Staff Report: Site Plan Amendment 82005009C, Woodcrest

Request to move several air conditioning units, which in turn reduces the side yard setbacks, on lots 11 through 19 and to alter the slab elevations and driveway grades on lots 45, 46, and 47. Project is located on MD 355 approximately 2,200 feet north of MD 121; Clarksburg Master Plan.

RECOMMENDATION: Approval of the site plan amendment.

Example of Changes to Building Restriction Lines for Side Yards

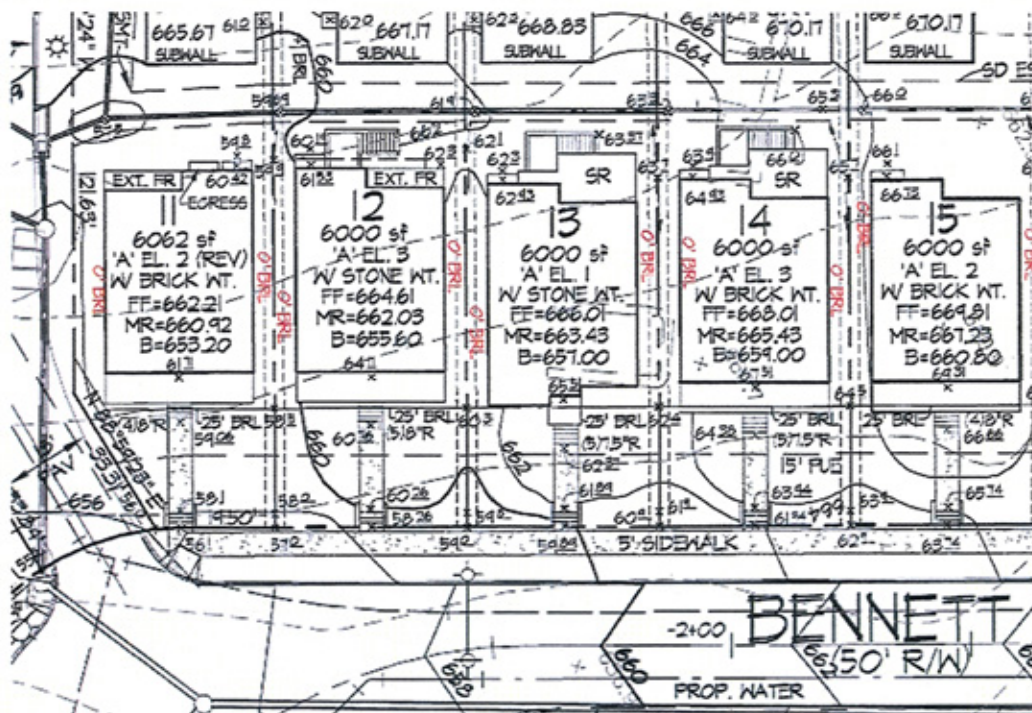
1. Revise side yard setback on single family detached lots 11 through 19 in Block B to accommodate the relocation of air conditioning units.

2. Raise the slab elevations on lots 45 and 46 by one foot.
3. Lower the garage elevation on lot 47 to reduce the driveway slope below 12%.
4. Grading changes associated with the changes in the slab elevations.
